Brewster Wind Farm

Appendix B – Environmental Noise Assessment Audit

Verification Report

*of the
Brewster Wind Energy Facility
Pre- Construction Noise Assessment
July 2024*

Figure 1: Planning Scheme (nearest high noise amenity zoned areas); (nearest WTG >3km)

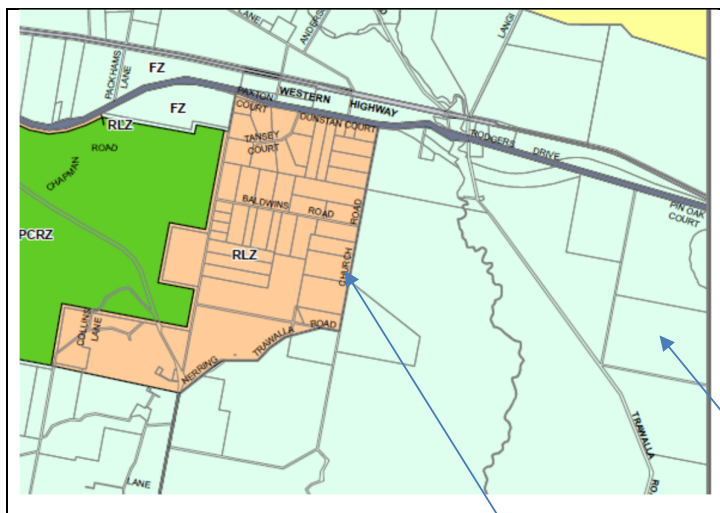
I therefore concur with the determination within the noise assessment report that a standard noise limit of 40 dB LA90 applies for noise sensitive locations within the Farming Zone. It is noted that a number of noise-sensitive locations to the west are located in other zones i.e. Rural Living (refer Figure 1). The Cherry Tree Wind Farm VCAT decision does not advise on these zones but the recent Planning Panel decision for the Golden Plains Wind Farm indicated that similar zoning is likely to be of 'High Amenity' (i.e. '... zoned Township Zone and Low Density Residential Zone are a high amenity for the purposes of the Standard' (ref PA1700266, 29 April 2019).

Therefore the Rural Living zone situated approximately 3.5 km from the nearest turbine to the west are potential high noise amenity areas (refer Figure 1).

Figure 2: Predicted noise contours (from Figure 1 MDA, 2024)

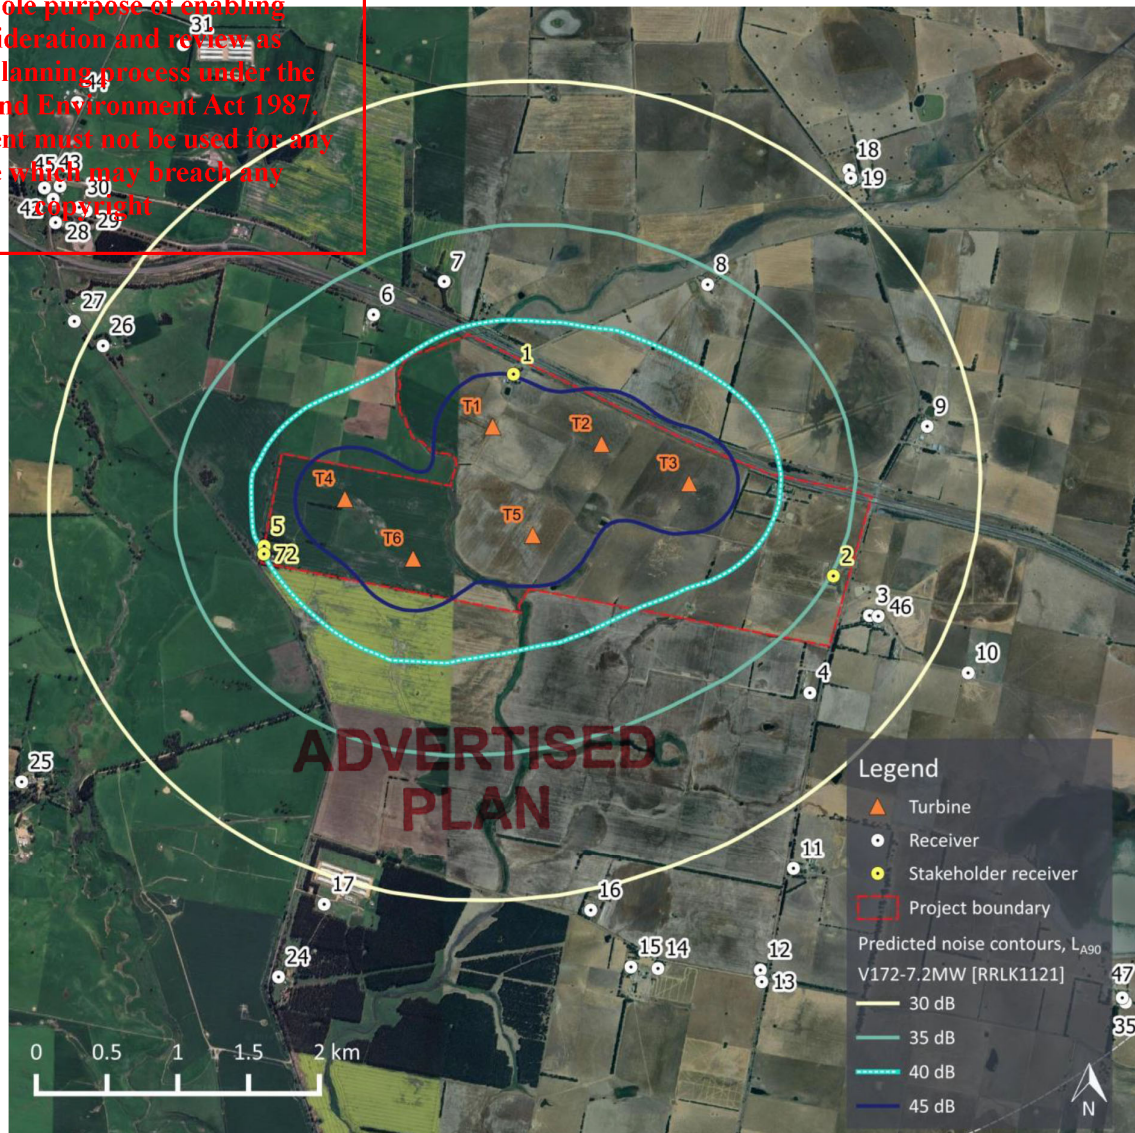
A map of the proposed turbine locations with predicted noise contours for the candidate turbine and consideration of cumulative impact from the adjoining WEFs, the nearest being the Stockyard Hill wind energy facility, has been taken from the subject report and reproduced in Figure 2.

The WEF covers a relatively small area with three (3) non-stakeholder NSL's falling within the predicted 35 dB L_{A90} to 40 dB L_{A90} noise contours (refer Figure 2). The nearest turbine to a non-stakeholder NSL is assessed to be over 1.0 km (i.e. NSL #6).
